Date: 23 June 2011
Contact: Mitch Longhurst
Location: Implementation & Assessment Branch, Nerang
Telephone: (07) 5582 8866
Your reference: ABMDiulioR10511
Our reference: PN151346/23/DA1
Application No: ROL201100066

INFORMATION REQUEST

L2 RP205586 : 35 Carrington Road Bonogin

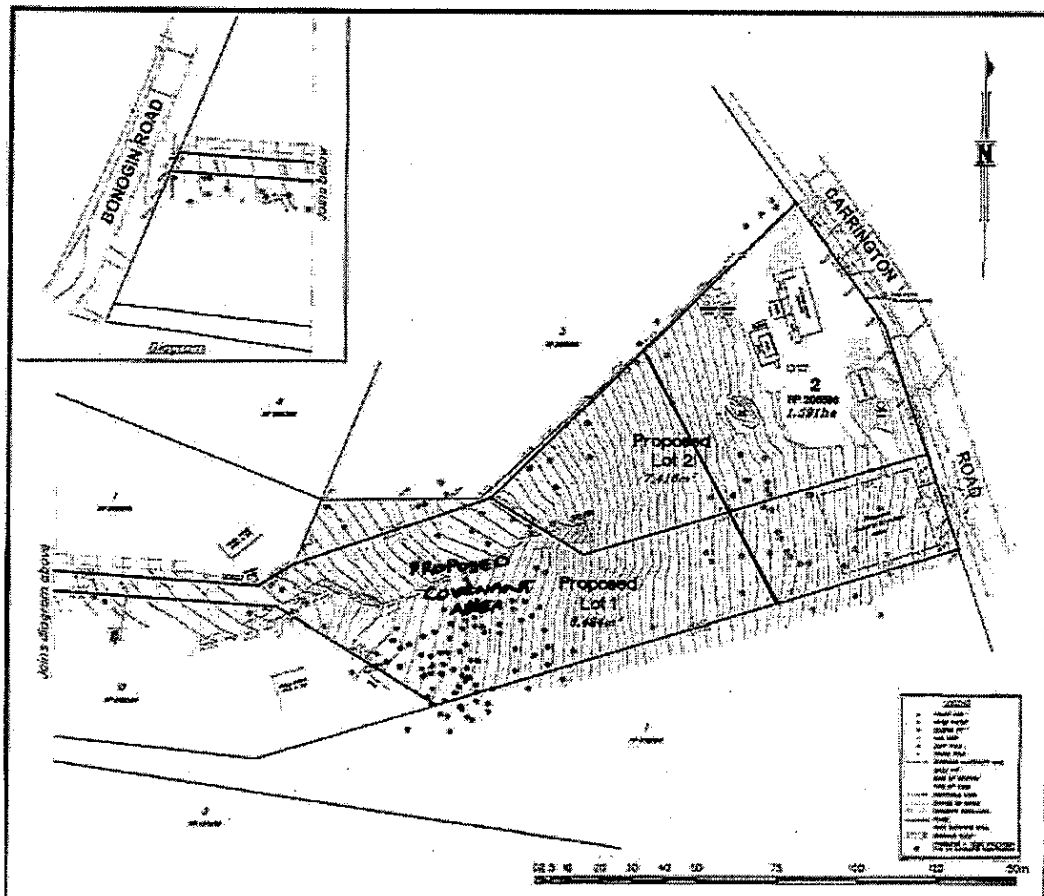
- a Description of the proposed development including a plan showing the location of the covenant areas as marked up on the below scanned copy of the Contour & Detail Survey with Plan of Subdivision Overlay, DWG No6188.15 SUB DET, Dated 22/03/2011, Prepared by Arnold Development Consultants.
